Historic District Review Committee

Staff Report

CAPP2011-0008

CAPP 2011-0008 Murley: Demolition of Existing Garage and Construction of New Garage. PIN # 455-38-3143.

Figure 3: Currently Proposed Garage Door
source: www.amarr.com

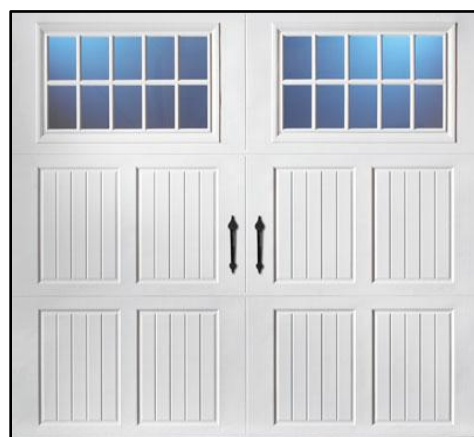
During the pre-application meeting, Staff suggested incorporating details from the existing garage doors into the design, such as the carriage style strap hinges. The elevations indicate that the paired garage doors on the east elevation, visible from Sands Road, will be Amarr Garage Doors – Classica Collection. The proposed doors have two windows per door (each with divided ten lites) and 12 recessed panels each with inset simulated bead-board, seen in figure 3. This proposed door style is not consistent with the otherwise simple garage design, the existing house, or the Quaker style of Lincoln. A simplified door with strap hinges similar to the existing door would be more compatible with the style of the garage and the existing house, in keeping the Guidelines for accessory structures (Goose Creek Guidelines, Guidelines for Site Elements, Accessory Structures and Breezeways, page 47, Guideline 5). A wide variety of door styles are available that would be more in keeping with the character of the property and surrounding village.

The Guidelines state that wood is the preferred material for doors but that composite products may be considered in new construction (Goose Creek Guidelines, Guidelines for New Construction, Doors Windows and Shutters, page 72, Guideline 7). While a composite product is preferred over metal, a steel door is preferable to materials such as vinyl and the HDRC may approve alternative materials on new construction projects when the proposed material “*replicates the visual qualities and workability of the original material*” (Goose Creek Guidelines, Guidelines for New Construction, Materials and Textures, page 80, Guideline 9).

7. The proposed garage doors on the front elevation are overly articulated and not in keeping with the style of the existing house or the Goose Creek District. A more simplified door with elements of a carriage style such as strap hinges and handles would be more in keeping with the District and the house. The use of steel doors is preferable to vinyl and will emulate wood when viewed from Sands Road which meets the Guidelines for materials.

Staff recommends a condition of approval requiring a simplified door design for the two front elevation garage doors with details (such as strap hinges and handles) reminiscent of the existing wood door. The applicant is researching alternative door designs and will provide additional options at the meeting for further discussion with the HDRC.
